1. App# 2023-5371; 6672 E. Main St; Chase Bank; Major Site Plan

RE: Vaughn Benson; 6672 E. Main Street: Major Site Plan Application

Subject: Staff Report for: JP Morgan Chase Bank – East Main St and Rosehill Road

MAJOR SITE PLAN FOR
JPMORGAN CHASE BANK
6672 EAST MAIN STREET
REYNOLDSBURG, OHIO 43068

SITE PHOTOMETRIC PLAN

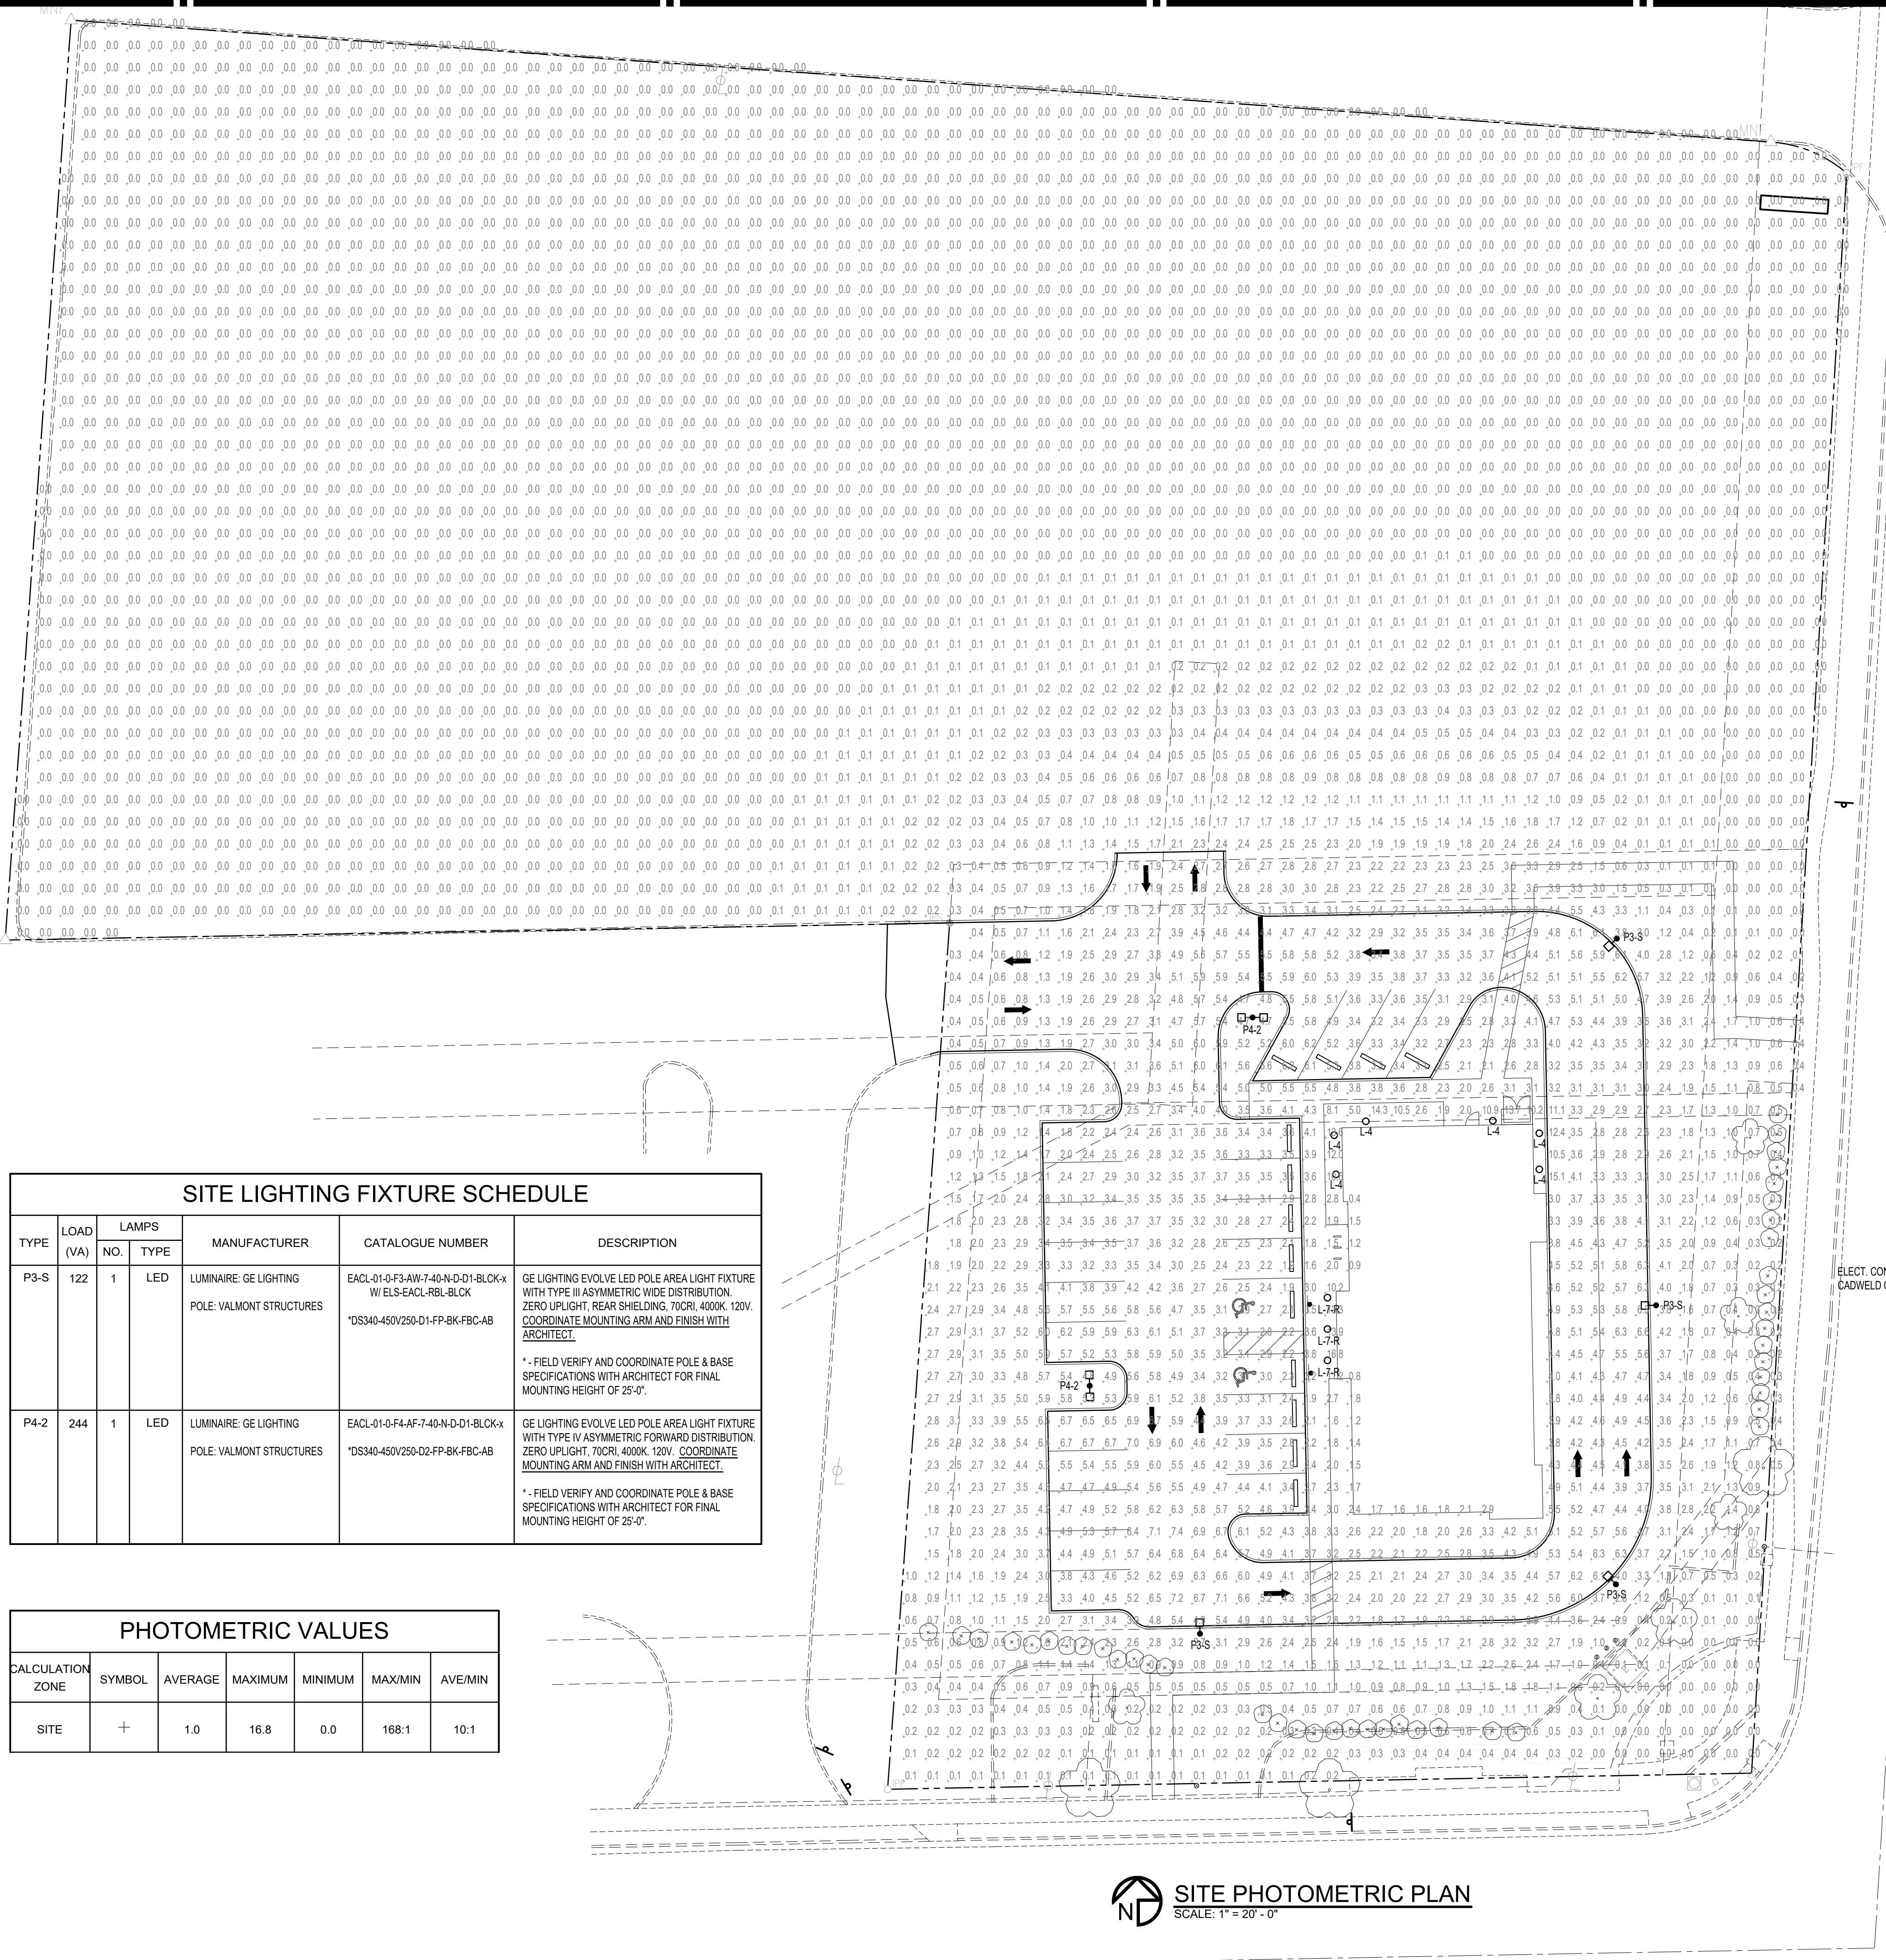
- h. **Lighting:** The code requires average horizontal illumination level on the ground floor not to exceed three foot candles. The average horizontal illumination level is 1 foot candle based on the photometric plan provided. The proposed parking lot lighting is cut-off lighting, which meets the code requirements. The maximum allowed height for parking lot lighting is 20 feet. The applicant is requesting 25 foot parking lot lighting. The required parking lot lighting height will need to be reduced to 20 feet, or a variance would be needed for the site.

- a. Staff recommends approval of the Major Site Plan with the following conditions:
 - i. On the lighting plan, change the parking lot light pole height from 25 feet to 20 feet in height. Section 1105.09.B.ii
 - ii. On landscaping site plan, depict the 6 foot minimum landscaping setback line on the site plan. Section 1105.07.F.ix
 - iii. On the Landscape site plan, update the Landscape Code Requirements table, H.i.2 to state 14" provided throughout interior landscaping. Section 1105.07.H.i.2.a
 - iv. Have the applicant provide more detailed information regarding the trash enclosure such as height, material and opacity to meet the code requirement. Section 1105.07.K.ii
 - v. Provide two physical and one electronic updated Major Site Plan copy to staff, showing the required changes have been made, to meet the conditions mentioned above.
